11-0509-4-01
January 9, 2017

Re: **Proposed Amendments to Darien Zoning Regulations
Corbin Subarea Parking Related Issue
Darien, Connecticut**

We have developed this response to questions from Chairman Sini's Email dated 1/4/17. In particular question No 6 below.

Figure1: Required Parking Dimensions

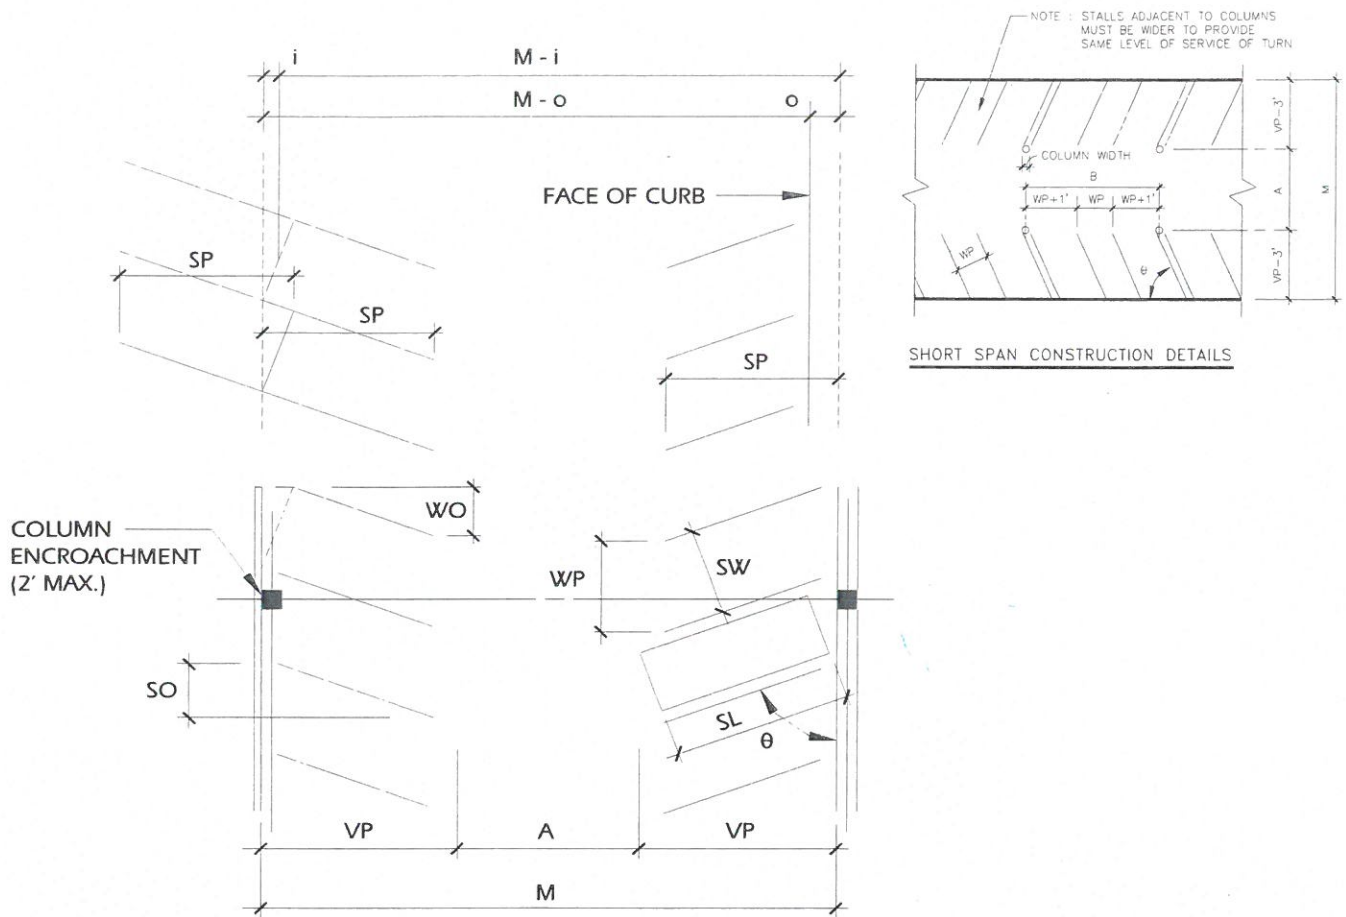
Question 6. *Page A-100 Parking Design Standards: By reducing width and length of stalls and lot width standards, how many additional parking spaces are gained. Please compare these proposed metrics to the size of a Chevy Suburban and plan to offer expert testimony that the proposed metrics are consistent with industry standard.*

- DARIEN 2016 Plan of Conservation and Development, in which it recognizes a parking stall width of 9 feet and length of 18 feet has been adopted in most communities; and the current parking design standard in Darien should be re-evaluated.
- Recommended Zoning Ordinance Provisions (Your Guide to Planning, Designing, Constructing and Managing Facilities, Including Off-Street Parking Spaces), dated 2012 and researched and published by the National Parking Association and its Parking Consultants Council, which is recognized as the parking industry standard. This document recommends a parking stall width of 9 feet wide by 18 feet long with a 24- foot aisle; and a parking bay width of 60 feet with 90-degree parking and a two-lane/two-way aisle for traffic flow. Attached is Figure 1: Required Parking Dimensions (page 42) and Table 1: Required Parking Dimensions (page 43) of this document.

The parking space dimensions in the proposed Text Change are based on existing and current reliable research and guidelines developed and published by nationally recognized professional organizations used in our profession, as well as Parking-related Studies conducted for the Town in 2007 and 2015; and parking stall dimensions recognized in the DARIEN 2016 Plan of Conservation and Development. The proposal is not changing the stall width of 9 feet, only the stall length from 20 feet to 18 feet.

By reducing the bay width from 64 feet to 60 feet approximately 65 parking spaces are gained in the conceptual parking layout plan.

The Chevy Suburban is 18'-8" in length. These vehicles will slightly infringe into the 24-foot aisle but will have no problem in pulling into a 9-foot wide stall or backing out into the 24-foot aisle. A vehicle parked in a 90-degree parking stall requires a distance equal to its length, at a minimum, to back out of the space. The 22'-8" aisle width area [assuming a Chevy Suburban is also parked on the other side of the aisle], is of sufficient width to accommodate this backing out maneuver in a safe manner. In addition, the resultant 11'-4" travel lane is acceptable for vehicles traveling at low speeds to safely avoid this minor extension for this type of vehicle.
